Road Safety Audit Response Report

Report title:	Lye Lane, Bricket Wood, Stage 1 RSA Response
Date:	05/06/24
Document reference and revision:	P2584 Stage 1 RSA Response
Prepared by:	Paul Mew Associates
On behalf of:	JD Rudkin (Builders) Ltd

LYE LANE BRICKET WOOD, ST ALBANS

Stage 1 Road Safety Audit

231436-CON-XX-00-SK-C-0004
West Riding / Lye Lane Proposed Uncontrolled Crossing

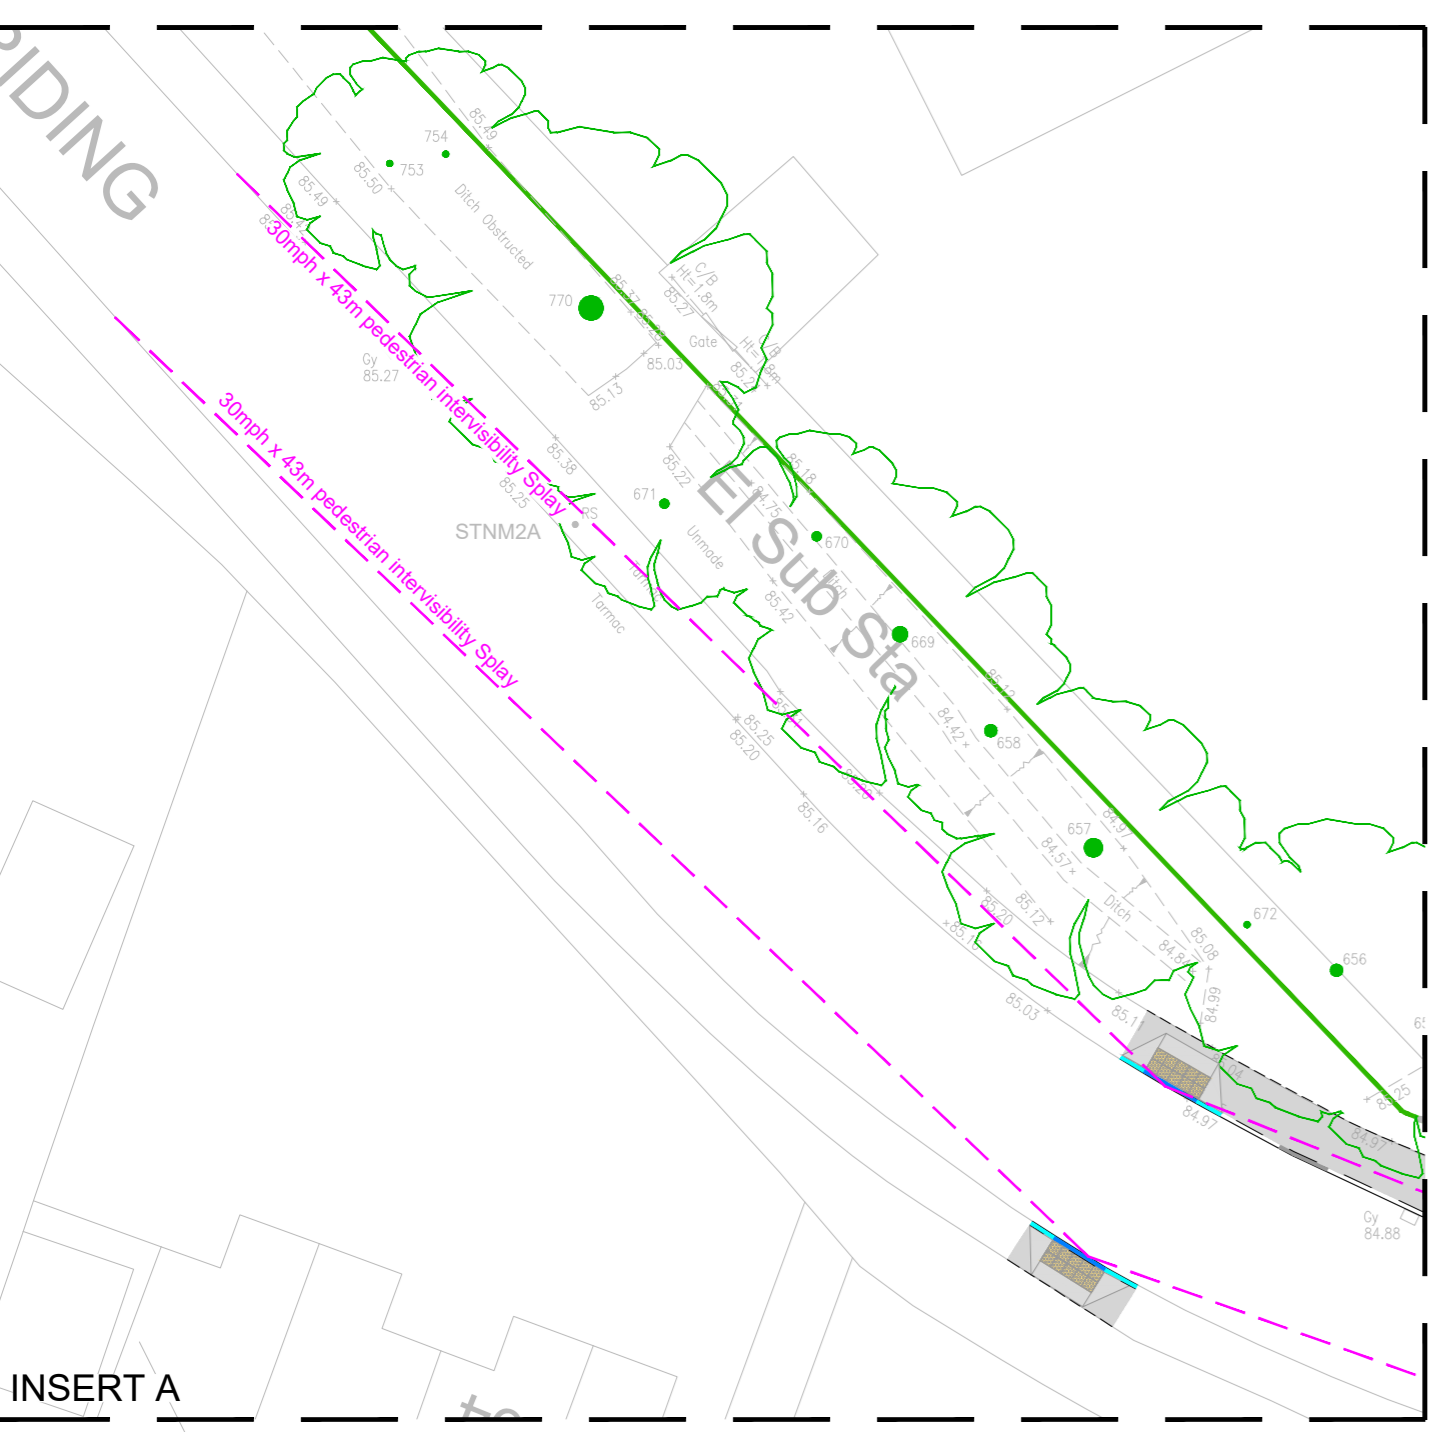
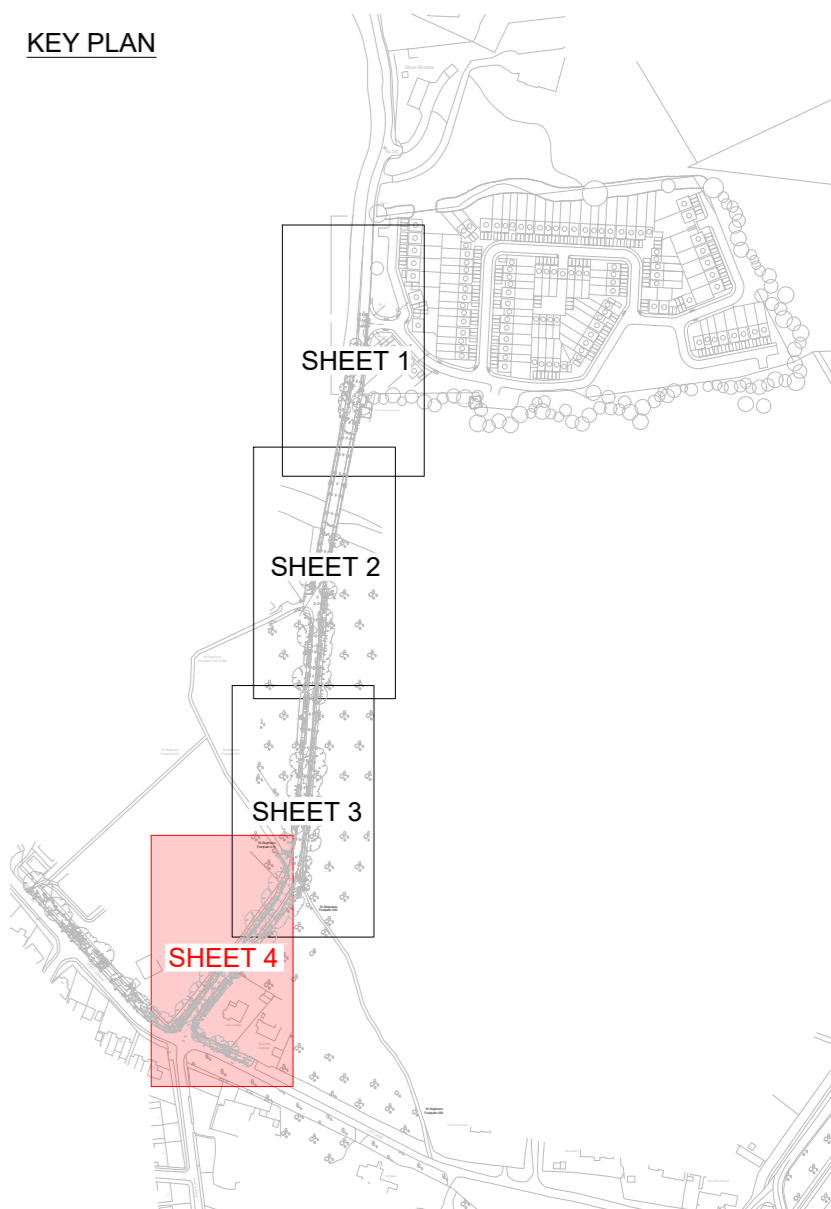
RSA problem	RSA recommendation	Design organisation response	Overseeing Organisation response	Agreed RSA action
<p>3.1 PROBLEM</p> <p>LOCATION: Lye Lane J/w West Riding Uncontrolled crossing points.</p> <p>SUMMARY: Insufficient pedestrian to driver intervisibility. Risk of vehicle to pedestrian type collisions. The proposed uncontrolled crossing point located along the north side of West Riding have a reduced visibility to the right due to the existing bend in the road, the trees and vegetation. This may increase the risk of vehicle to pedestrian type collisions if pedestrians cross the carriageway at this location.</p>	<p>The Audit Team recommend that the driver to pedestrian inter visibility is not compromised at this crossing point..</p>	<p>The Proposed uncontrolled Crossing has been moved approximately 8 metres back from the junction. This will allow a better intervisibility splay.</p> <p>The new uncontrolled pedestrian crossing near West Riding / Lye Lane Junction meets the intervisibility splay requirements of 43 m in line with Mfs 30mph speed limit at West Riding Road.</p> <p>The intervisibility splays are within the public highway ownership.</p> <p>Intervisibility splays will be kept clear of any impediments (planting / vegetation, fencing) over 0.6m above ground level that may restrict visibility at these locations. Pedestrian – vehicle intervisibilities of 43m (in line with Mfs SSD speeds can be achieved and are shown in the Revised drawings attached to this report 231436-CON-XX-00-SK-C-0004.</p>

<p>3.2 PROBLEM</p> <p>LOCATION: Lye Lane J/w West Riding Uncontrolled crossing points.</p> <p>SUMMARY: Insufficient pedestrian to driver intervisibility. Risk of vehicle to pedestrian type collisions The proposed uncontrolled crossing point located along the south side of West Riding have a reduced visibility to the right due to the existing trees and vegetation located in the verge and also parked vehicles immediately adjacent to the proposed crossing point. This may increase the risk of vehicle to pedestrian type collisions if pedestrians cross the carriageway at this location.</p>	<p>The Audit Team recommend that the driver to pedestrian inter visibility is not compromised at this crossing point.</p>	<p>The Proposed uncontrolled Crossing has been moved approximately 8 metres back from the junction. This will allow a better intervisibility splay.</p> <p>The new uncontrolled pedestrian crossing near West Riding / Lye Lane Junction meets the intervisibility splay requirements of 43 m in line with Mfs 30mph speed limit at West Riding Road.</p> <p>The intervisibility splays are within the public highway ownership.</p> <p>Intervisibility splays will be kept clear of any impediments (planting / vegetation, fencing) over 0.6m above ground level that may restrict visibility at these locations. Pedestrian – vehicle intervisibilities of 43m (in line with Mfs SSD speeds can be achieved and are shown in the Revised drawings attached to this report 231436-CON-XX-00-SK-C-0004.</p>

PROPOSED UNCONTROLLED PEDESTRIAN CROSSING WITH BLISTER TACTILE PAVING. REFER TO "INSERT A" ABOVE FOR CONTINUATION.

VISIBILITY SPLAYS AS TAKEN FROM PMA BRICKET LODGE, LYE LANE DRAWINGS P2584/RSA APPENDIX A AND APPENDIX B, DATED 04/06/2024.

Lye Lane / St. Stephens Footpath 015 Crossing Intervisibility Splay

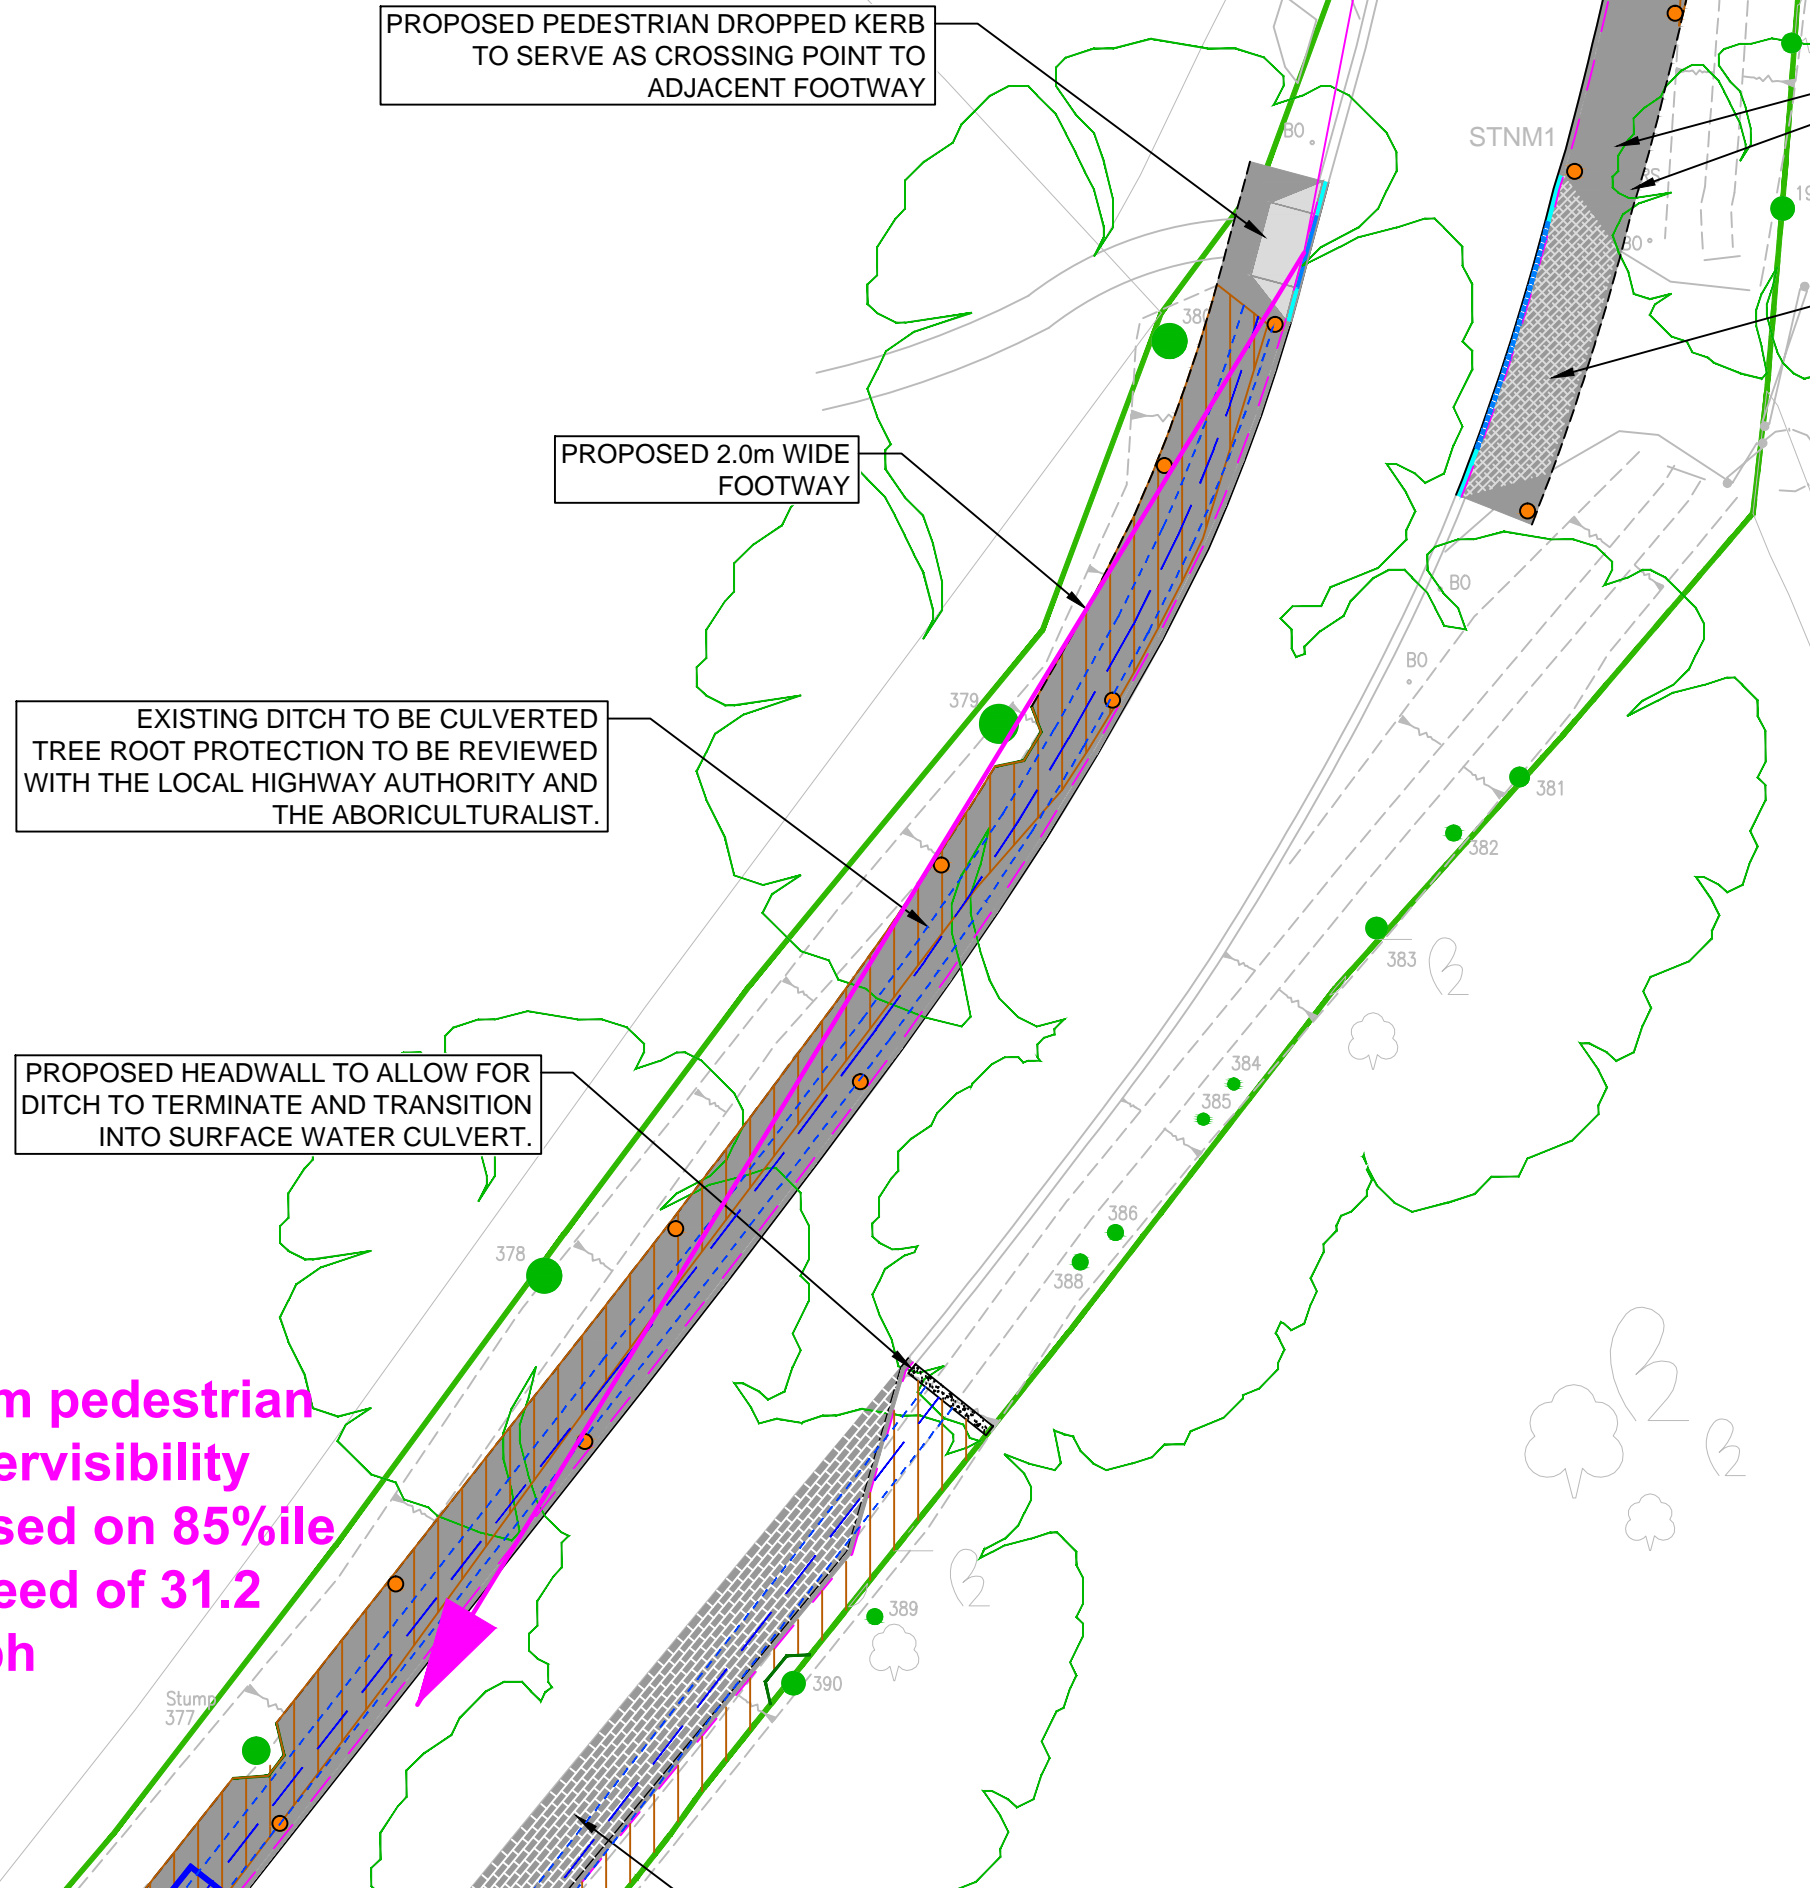
The proposed uncontrolled crossing point located along the west side of Lye Lane has a reduced visibility to the right due to the existing trees and vegetation located in the verge.

Insufficient pedestrian to driver intervisibility at this location may increase the risk of vehicle to pedestrian type collisions

45m pedestrian
intervisibility
based on 85%ile
speed of 31.2
mph

231436-CON-XX-00-SK-C-0001
Bricket Lodge – Site Access Visibility Splay

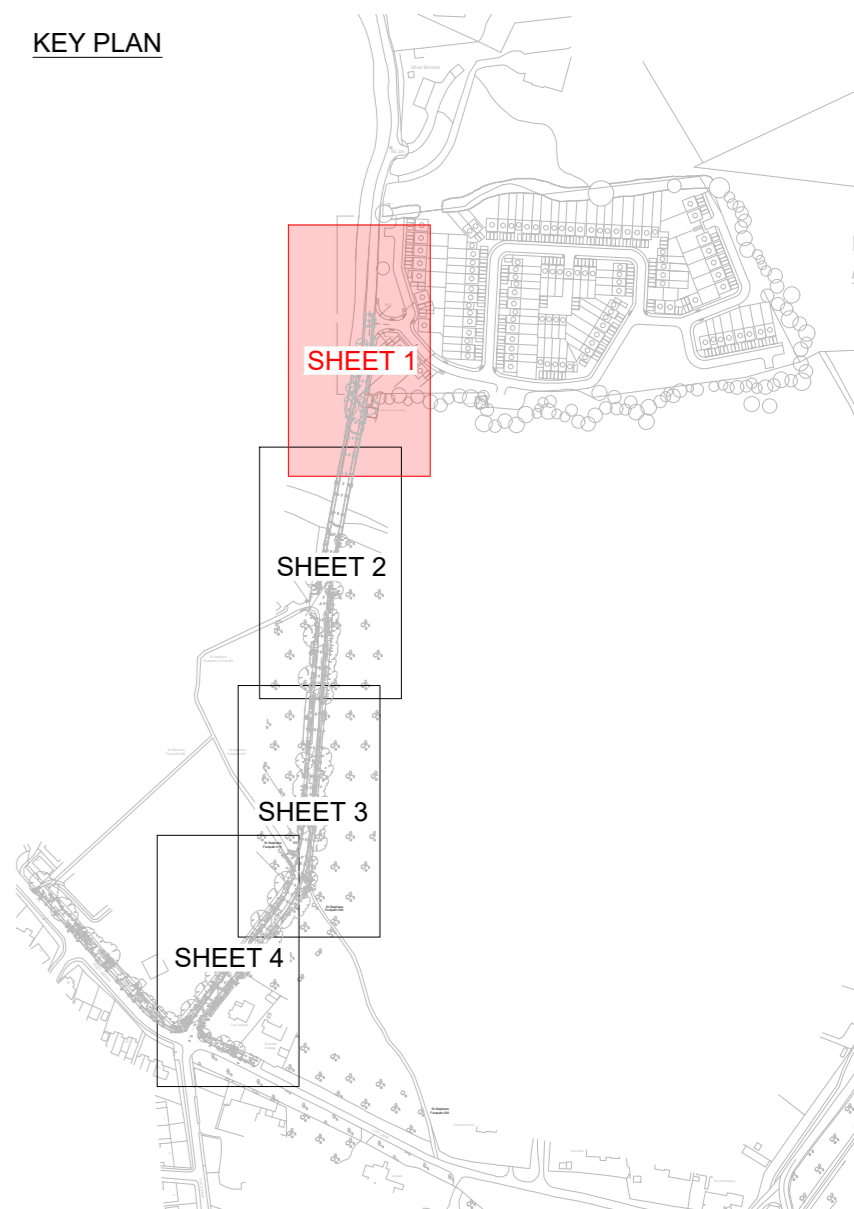
<p>3.7 PROBLEM</p> <p>LOCATION: Proposed Bricket Lodge Access.</p> <p>SUMMARY: Insufficient visibility splay may increase the risk of vehicle to vehicle pull out type collisions. The drawings provided show that the proposed give way markings are to be located behind the existing ditch. No visibility splays have been indicated on the General Arrangement drawings and there is no evidence on the site clearance drawings that the existing hedges within the visibility splay are to be removed. Insufficient visibility splays may increase the risk of vehicle to vehicle pull out type collisions.</p>	<p>The Audit Team recommend that the visibility splays at the junction are not compromised by any hedges or other obstructions.</p>	<p>Vehicle visibility splays of 47 m facing north (in line with 85th %ile speeds of 32.2 mph) can be achieved and are shown in the Revised drawings in 231436-CON-XX-00-SK-C-0001.</p> <p>Vehicle visibility splays of 45 m facing south (in line with 85th %ile speeds of 31.2 mph) can be achieved and are shown in the Revised drawings in 231436-CON-XX-00-SK-C-0001.</p> <p>Intervisibility splays will be kept clear of any impediments (planting / vegetation, fencing) over 0.6m above ground level that may restrict visibility at these locations. Pedestrian – vehicle intervisibilities of 47/45m (in line with 85th %ile speeds can be achieved and are shown in the Revised drawings attached to this report 231436-CON-XX-00-SK-C-0001.</p>

2.4m x 45m sightline based on 88th %ile NB Speed of 31.2mph

2.4m x 47m sightline based on 88th %ile SB Speed of 32.2mph

231436-CON-XX-00-SK-C-0003-P04
Lye Lane Footpath Error Correction Plan

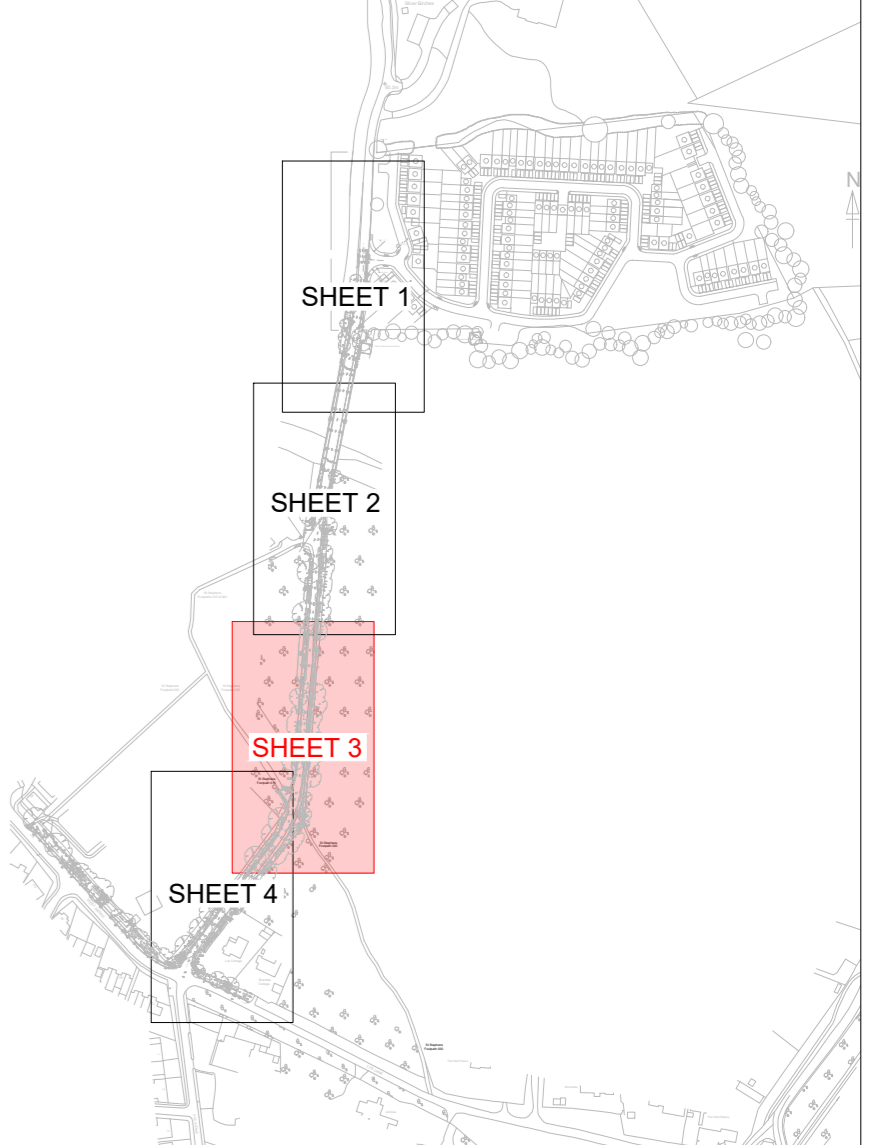
<p>Comment; 1.16 No Departures from Standard have been provided by the Design Team. However there are a number of locations along the Lye Lane footway proposals where the footway width is reduced to 1.2 m. The Design Team should confirm that this has been accepted by the Highway Authority together with any associated mitigation measures.</p>		<p>This is a drafting error, an annotation states 1.2m footpath and should read 2m. This has since been corrected and reissued to the RSA team.</p> <p>The planned footpath is uniform at 2m wide. There are 7 narrow sections around tree trunks where the footpath does not measure less than 1.5m. this can be seen in the revised plans attached to this report 231436-CON-XX-00-SK-C-0003-P04</p>		
---	--	--	--	--

PROPOSED 2m WIDE FOOTWAY
